TO: Winnebago Industries, Inc. Dealers

SUBJECT: Campaign #112 – Propane Tank Bracket

INSTRUCTIONS TO PERFORM CAMPAIGN 112

A

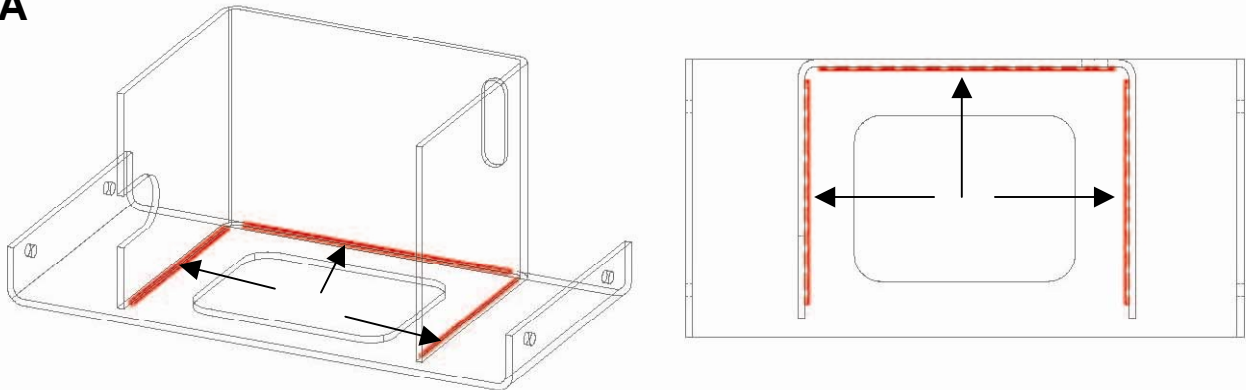
4. Go beneath the vehicle to inspect the welds of the bracket assembly. The welds should be placed in the position and manner shown in red. See Photo A.

Welds shown in red above

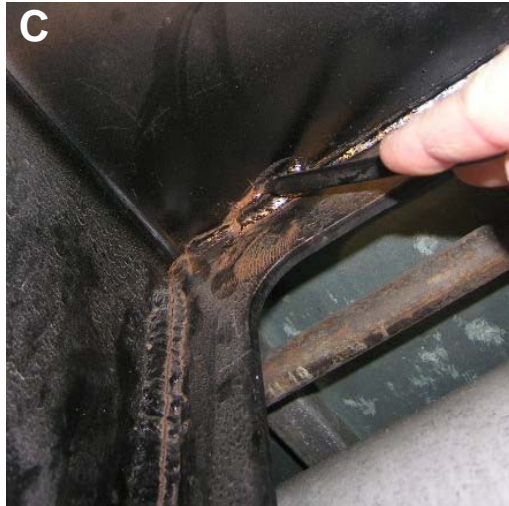
5. Inspect the welds for cracks, rust, or gaps between the weld and plate. See Photos B and C as an example of improper weld penetration, cracking, and fatigue.

6. Using a ball peen hammer (welding hammer) or similar tool, test the surfaces of the bracket by using the hammer to impact the surfaces to assure the bracket welds are proper and the bracket is firmly attached to the chassis rail.

Should the welds show any signs of failure, contact the Winnebago Industries Technical Service Department at (866) 653-4329. Winnebago staff will work with your dealership in order to complete repairs.
